# **BULLETIN 5647**

## **MK7 MINECRUISER EXHAUST**

Synopsis: This Bulletin advises product recall for Mk7 MineCruiser exhaust system

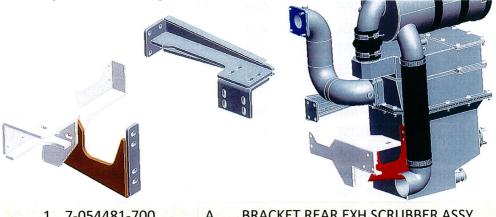
GE Industrea has been notified of a number of breaches where the exhaust pipe adaptor to turbo fixed connection has failed on a Mk7 MineCruiser. The joint failure is a breach of explosion protection that makes the diesel engine unsafe for operation in underground coal mines.

Mk7 MineCruiser vehicle operators are advised by way of this notice of a product recall for the Mk7 MineCruiser scrubber mounting brackets to rectify a fault with the exhaust system. The scrubber mounting bracket design has been reviewed and a new set of mounting brackets designed to provide improved support for the rigid pipe exhaust system. Mounting bracket assembly 7-054712-700 identify the new brackets.

1 7-054481-700 A BRACKET REAR EXH SCRUBBER ASSY

2 7-054482-700 A BRACKET FRONT EXHAUST SCRUBBER

4 7-054857-700 A MOUNT, CONDITIONER, ENGINE
